# 4 St George's Terrace 2014/3381/P & 2014/2311/L

<b>Delegated Report (Members Briefing)</b>		<b>Analysis sheet</b> N/A	<b>Expiry Date:</b> 16/07/2014
			<b>Consultation Expiry Date:</b> 26/06/2014
<b>Officer</b>		<b>Application Number(s)</b>	
Hannah Walker		1. 2014/3381/P 2. 2014/2311/L	
<b>Application Address</b>		<b>Drawing Numbers</b>	
Flat 1, 4 St. Georges Terrace London NW1 8XH		Refer to draft decision notice	
<b>PO 3/4</b>	<b>Area Team Signature</b>	<b>C&amp;UD</b>	<b>Authorised Officer Signature</b>
<b>Proposal(s)</b>			
1. External alterations including installation of a replacement steel staircase to the rear and replacement French doors and window (retrospective)			
2. Internal and external alterations with associated refurbishment works (retrospective)			
<b>Recommendation(s):</b>	Grant conditional permission Grant Listed Building Consent		
<b>Application Type:</b>	Planning permission Listed Building Consent

Proposal:  
External alterations including installation of a replacement steel staircase to the rear and replacement French doors and window (retrospective)

Project 4 ST GEORGES TERRACE NW1 8HX	Drawing Title GROUND FLOOR WINDOW wG 2	Scale	NTS	Drawing No. <b>C/513</b>
		Date	July 2014

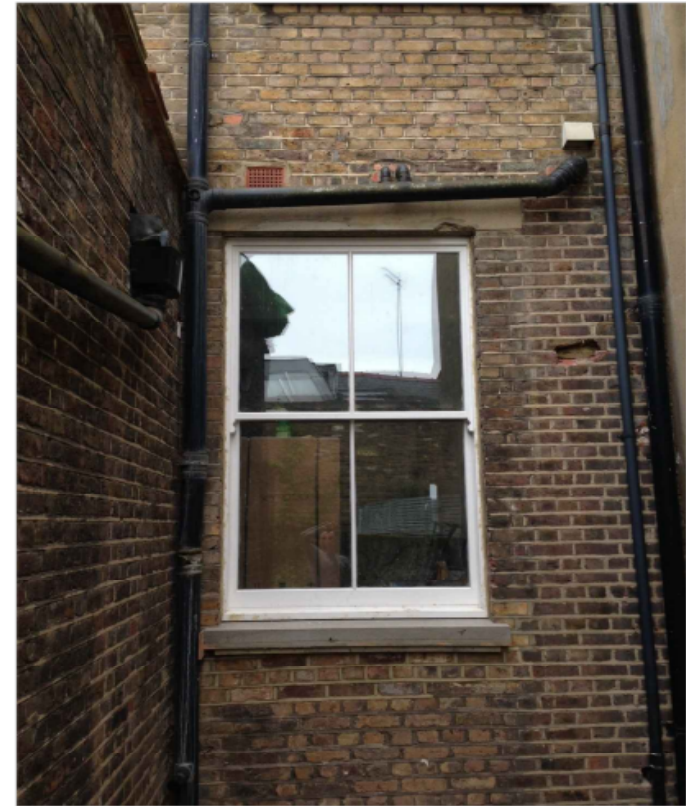
2.4 It is also proposed to replace a rear window at ground floor level (WG2). This formerly consisted of a pair of softwood double glazed casements. These have been replaced with a traditional timber double glazed sash window. The design of this is considered to be an enhancement and more appropriate for a listed building of this age and character. The proposed double glazed units are considered acceptable given that the previous units were also double glazed and that they have been inserted into a modified opening rather than an opening that retains its original character (it has had a flat concrete lintel installed).

Project 4 ST GEORGES TERRACE NW1 8HX	Drawing Title BASEMENT YARD AREA	Scale	NTS	Drawing No. <b>C/510</b>
		Date	July 2014

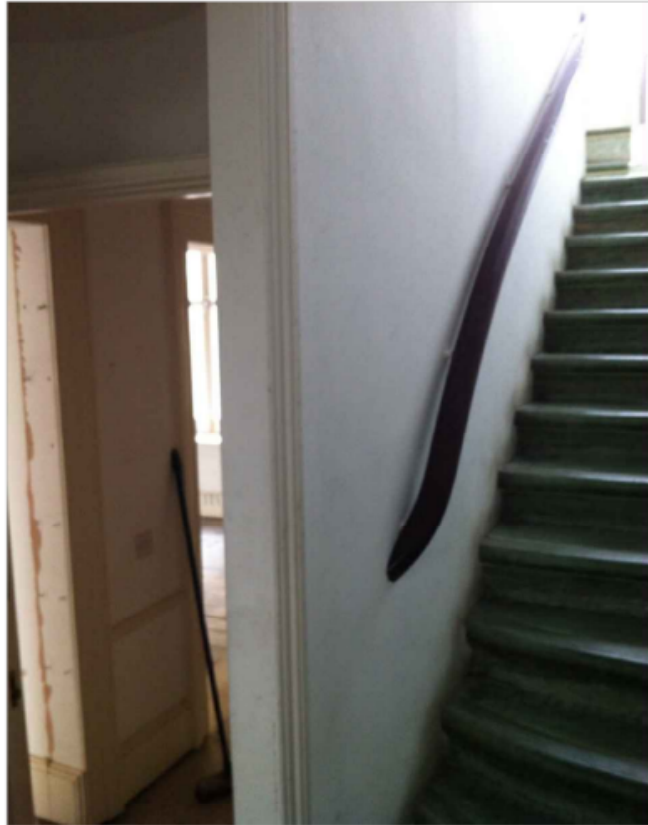
2.1 With regard to the replacement French doors within the rear lightwell at basement level (WB1 and WB2), the previous doors were inserted in the 1980s and were constructed of softwood with double glazed sealed units. The apertures themselves are clearly not original and have a flat rendered surround in the case of WB1 and a rendered flat concrete lintel to WB2. WB1 consisted of a pair of doors set into a wide opening, flanked by panels of glass blocks. These have been replaced by a pair of doors in the same location but with fixed glazed panels with openable toplights flanking them. The size of the aperture has not increased. The doors are painted softwood to a simple design, with 24mm double glazed units. The replacement of the unsympathetic glass blocks is a significant enhancement. Opening WB2 previously consisted of a pair of French doors. These have been replaced with simple French doors with openable toplights. Once again the aperture has not been increased in size.

2.2 The proposed replacement French doors are considered acceptable. The openings themselves have not been increased in size. Given the discrete position and simple design of the doors within the rear basement lightwell, the design and configuration of the previous 1980s doors, and the enhancement achieved through the replacement of the panels of glass blocks, the works are considered to preserve the special interest of the listed building.
